YARRA CITY COUNCIL

Internal Development Approvals Committee

Agenda

1.1 PLN17/0959 - 1E Marine Parade, Abbotsford - Use and development of the land for the construction of a mixed use building (permit required for office and retail (food and drink premises) uses) and a reduction in car parking requirements.

Figure 1 (advertised plans)

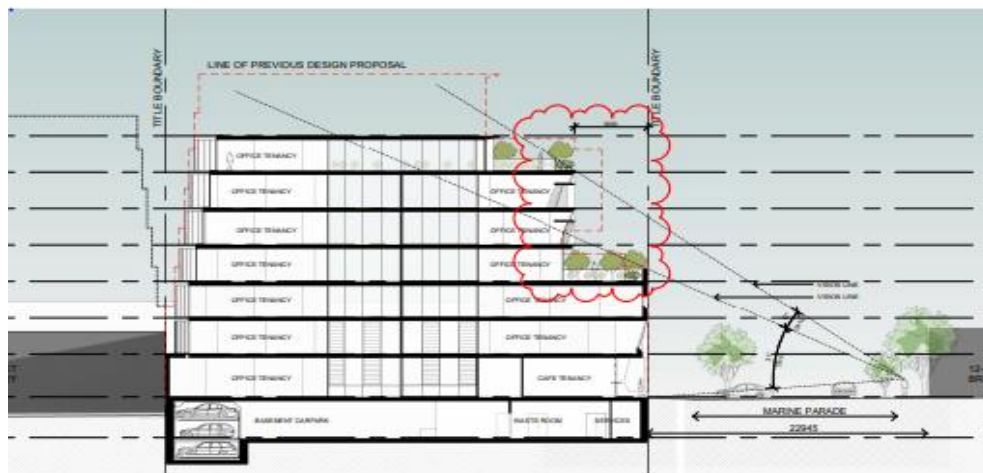
115. This outcome is evident in the following images (advertised plan images below in figure 1), with the previously proposed building envelope illustrated in red (figure 2). These images demonstrate how massing, articulation and changes in surface treatment have been utilised to relate the taller building to the surrounding scale, as recommended in Clause 22.10-3.3 of the Scheme.

Poor light and ventilation to the Ground and Level 1

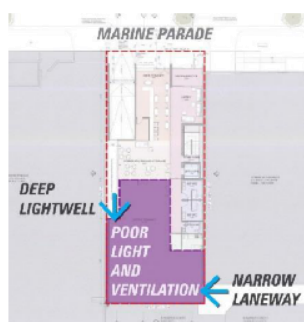
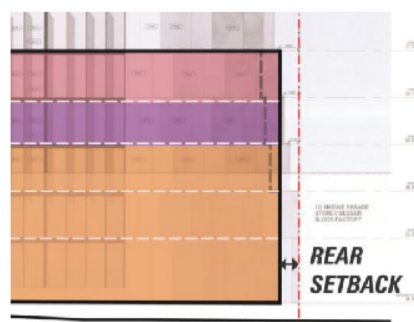
In terms of the rear interface, we are concerned with the Ground and Level 1 boundary development for light and ventilation reasons, which will be discussed later in this memo. Upper levels are proposed to incrementally setback from the rear boundary to allow solar access and enjoy views across the river corridor.

Whilst we support the party-walls to the east and west boundaries so as to achieve equitable development opportunities, a weakness lies with the lack of sunlight and ventilation to the southern portion of Ground and Level 1. The proposal is built to the side and rear boundaries with minimal opportunities for light and air. We acknowledge that the expectations of amenity must be tempered by the fact the proposal is for an office, compared to a residential use. We still recommend that the application demonstrate a reasonable level of amenity to Ground and Level 1. We would be supportive of the introduction of a setback along the southern boundary to, in a sense, extend the laneway and provide a courtyard terrace space at ground level for the rear offices to lookout onto.

Suggested rear setback

Previous Application – 30% upper levels visible

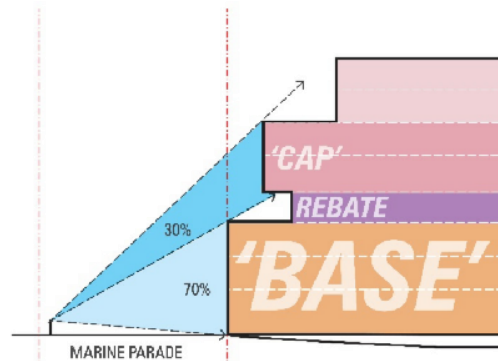
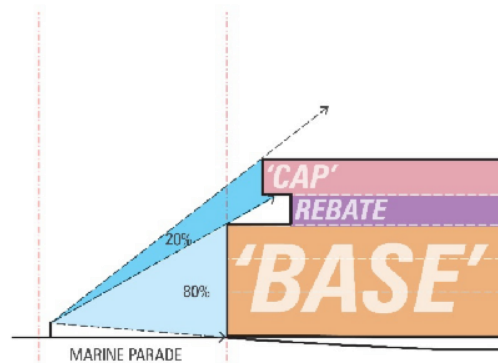
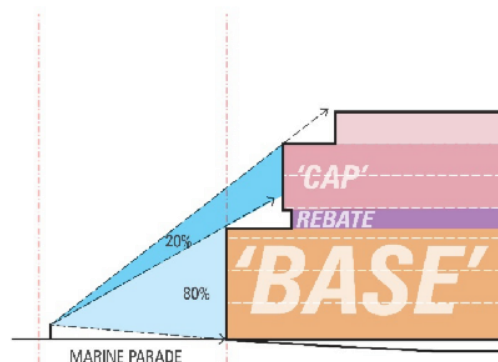
The previous plans adopted a massing strategy with a 'base' and a less visually 'subservient' upper level, resulting in the 'cap' being visible at 30% of the total view from across Marine Parade.

Our recommendations sought to retain the streetwall with a dominant presentation in the streetscape. While we recommended a height reduction to '5 storeys', we are supportive of the reduction in floor to floor heights, in combination with the increased upper level setbacks. This results in the same streetwall proportion to upper levels as our previous recommendation, which is 20% visible in the total view.

We consider this is an apt response within the streetscape of Marine Parade.

Bottoming out/scaping of a B99 design vehicle when traversing 2.0 metre long transition grade at the base of a 1 in 4 ramp grade section

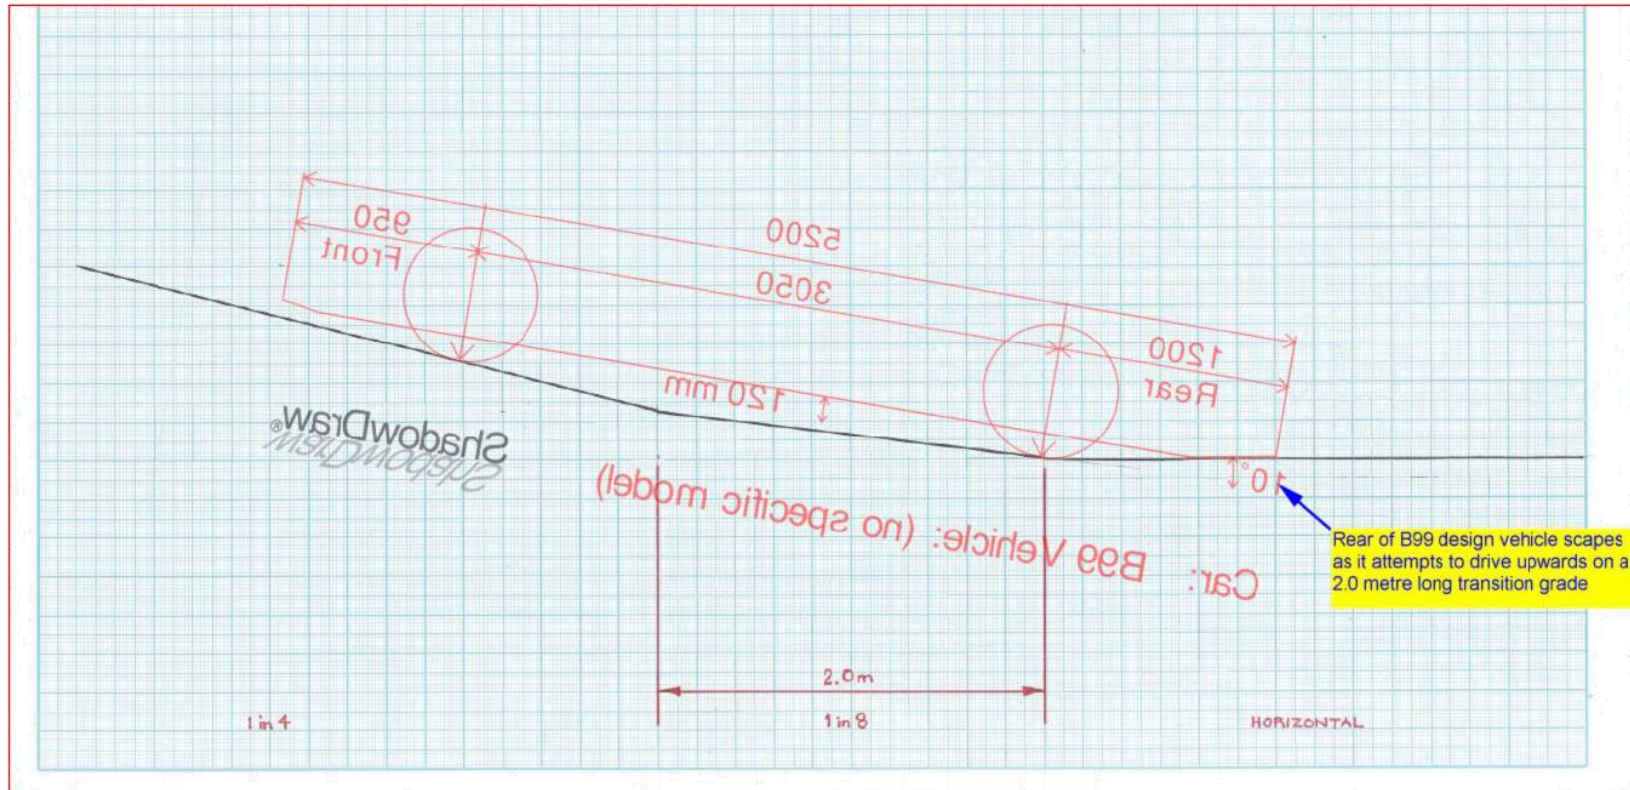
Ground Clearance for a B99 at a Sag Transition Grade
